County of San Diego
Planning & Development Services
BUILDING DIVISION

ACCESSIBILITY CORRECTION LIST

Multifamily Housing

Parking Facilities

CBC FIGURE 11A-1A(b) –
INTERNATIONAL SYMBOL OF ACCESSIBILITY
(WHITE FIGURE ON BLUE BACKGROUND EQUAL TO
COLOR NO. 15090 IN FEDERAL STANDARD 595B)

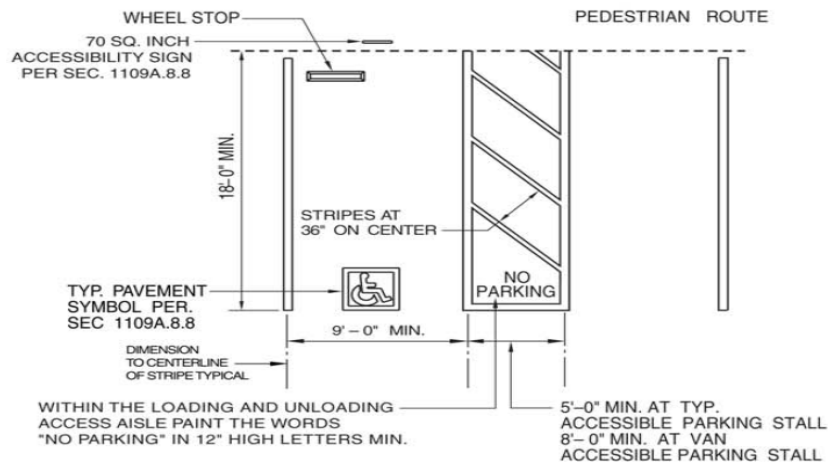
22. Detail surface identification complying with one of the following configurations at each accessible parking stall:

- ☐ Outlined 36-inch by 36-inch International Symbol of Accessibility per CBC Figure 11A-1A(b) in white on blue background and located for visibility by traffic enforcement personnel when vehicle properly parked
- ☐ Stall outlined or painted blue with International Symbol of Accessibility outlined in white or color contrasting pavement/background

- ☐ International Symbol of Accessibility symbol in white on blue background per CBC Figure 11A-1A(b)
- ☐ Minimum 70 square inches
- ☐ Minimum 80-inch vertical clearance above parking surface when in path of travel

CBC FIGURE 11A-2B – SINGLE PARKING STALL

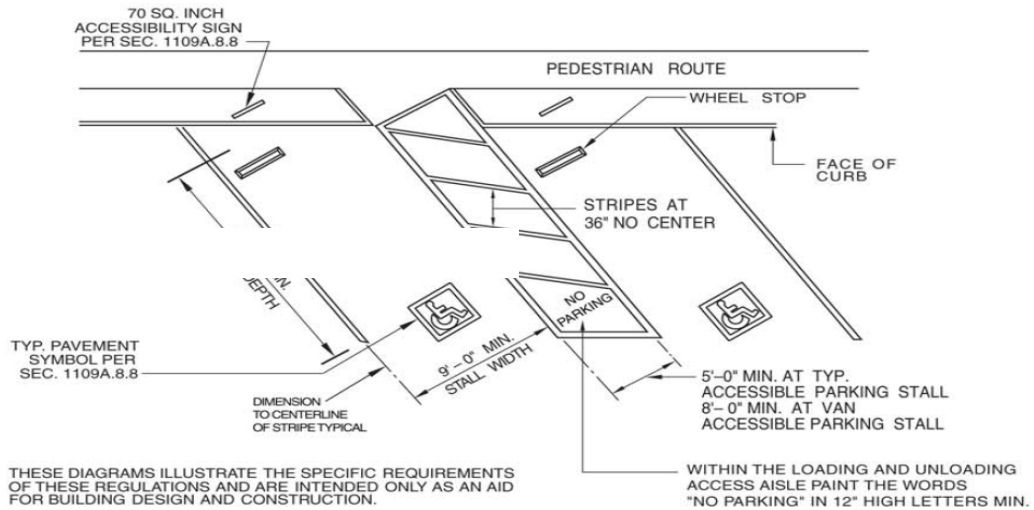
14. Where individual accessible parking spaces are provided, dimension the following per CBC Figure 11A-2B:

- ☐ Minimum 9-foot-wide by 18-foot-long parking stall
- ☐ Minimum 5-foot-wide by 18-foot-long access aisle on passenger side of vehicle

15. Where dual accessible parking spaces are provided, dimension the following per CBC Figure 11A-2A or CBC Figure 11A-2C:

- ☐ Two minimum 9-foot-wide by 18-foot-long parking stalls
- ☐ Minimum 5-foot-wide by 18-foot-long access aisle between parking stalls
